UNITED STATES PATENT AND TRADEMARK OFFICE

APPLICATION NO.	FILING DATE	FIRST NAMED INVENTOR	ATTORNEY DOCKET NO.	CONFIRMATION NO.
10/651,115	08/28/2003	Keith D. Mease	TN285	7863

Office Action Summary	Application No. 10/651,115	Applicant(s) MEASE ET AL.	
	Examiner Zachary M. Pape	Art Unit 2835

DETAILED ACTION

FIG. 1

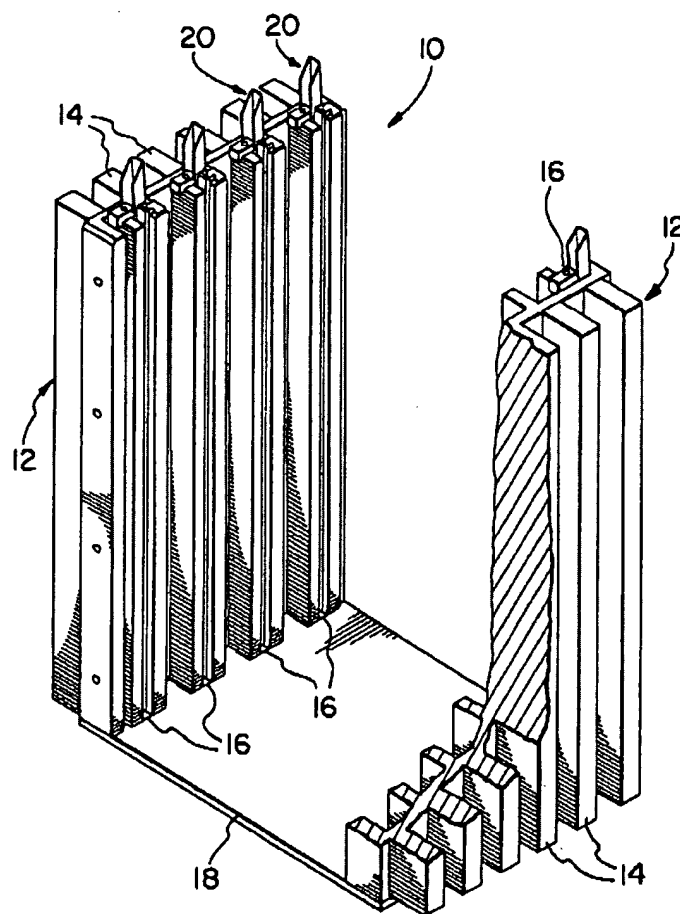
With respect to claim 1, Hughes et al. teaches a heat sink (10) configured to support an edge (82) of a circuit card (80), said heat sink comprising: a thermally conductive base (See present office action Fig 1 below); a plurality of thermally conductive heat dissipating fins (See POA Fig 1 below) extending perpendicularly from

With respect to claim 5, Hughes et al. further teaches a face disposed opposite said fins (See POA Fig 1 above), said base being configured to be mounted with said face abutting a heat-generating component (See POA Fig 1 above). [The Examiner additionally notes that, it has been held that the recitation that an element is "configured to" perform a function is not a positive limitation but only requires the ability to so perform and is therefore given little patentable weight. *In re Hutchison*, 69 USPQ 138.]

With respect to claim 9, Hughes et al. further teaches that the fins (See POA Fig 1 above) are oriented substantially parallel to one another (See Hughes Figs 1 and 2).

With respect to claim 18, Hughes et al. further teaches a heat sink (10) guiding one or more circuit cards (80) and transferring heat from one or more heat-generating components (Column 3, Line 62 – Column 4, Line 3), said heat sink comprising: a surface (Base as illustrated in POA Fig 1 above) defining one or more slots (16) configured to guide an edge of a circuit card; and heat dissipating fins (See POA Fig 1 above, also 14) thermally coupled to said surface, said one or more slots at least partially defined by adjacent parallel faces of said fins (See Hughes Figs 1 and 2), said one or more slots (16) having a depth smaller than the height of said fins (See Hughes

Fig 2

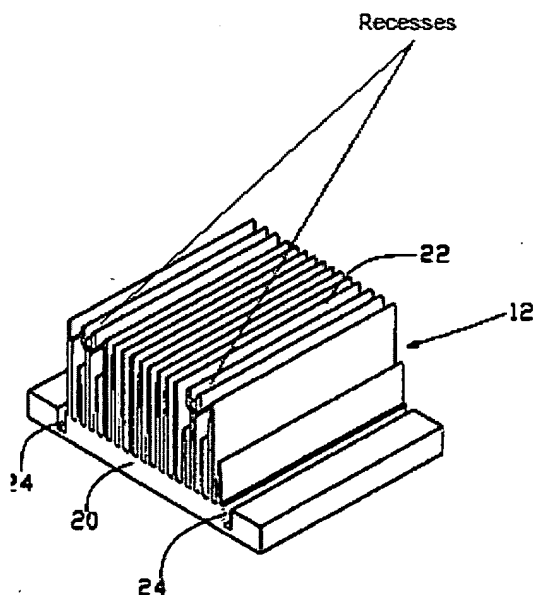
With respect to claim 1, Lo teaches a heat sink (10) configured to support an edge (74) of a circuit card (70), said heat sink comprising: a thermally conductive base (Generally 20); a plurality of thermally conductive heat dissipating fins (22) extending perpendicularly from said base; and one or more recesses (See Present office action Fig 1 below) at least partially defined by adjacent parallel faces of said fins (See Fig 1 below) the recesses having a depth smaller than the height of said fins, said one or more recesses being configured to support the edge of the circuit card.

With respect to claim 7, Lo further teaches that the recess is defined by a plurality of said fins (As illustrated in Fig 2 above).

computer system a heat sink (12) having a recess (See POA Fig 2 above) configured to receive an edge of a circuit card such that the recess orients the circuit card to enable mating the circuit card with a connector, the recess at least partially defined by at least one of a plurality of thermally conductive heat dissipating fins (22), the recess having a depth smaller than the height of said fins (See Lo Fig 1). Lo is silent as to a circuit card, and position the edge of the circuit card in the recess. Hughes et al. teaches the conventionality of a circuit card edge (82) which is positioned within a recess (16) of a heat sink (12). It would have been obvious to one of ordinary skill in the art at the time the invention was made to mount a circuit board in a heat sink recess as taught by Hughes with the teachings of Lo to make economic and efficient use of a heat sink (Column 2, Lines 3-7).
